## **Planning & Zoning Commission Regular Meeting**

Wednesday, November 10, 2021 at 6:30 PM

## **AGENDA**

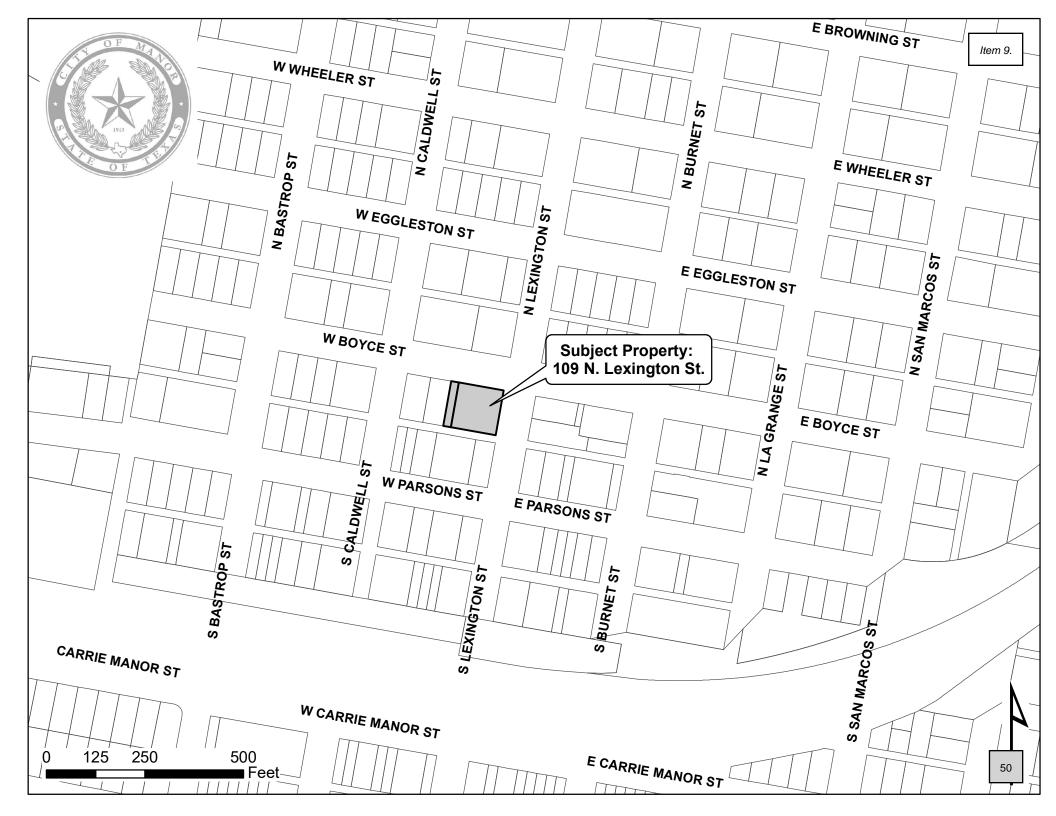
Our code requires that post-development stormwater flows off a property are equal to or less than predevelopment levels. This property in order to accommodate the minimum dwelling unit sizes and required parking does not have sufficient area for a typical detention pond. The peak flow in a 100 year storm event (Q100) for Study Point 1 (Boyce Street culvert) is 0.7 cubic feet/second (cfs) and the peak flow for Study Point 2 (alley) is 0.8 cfs.
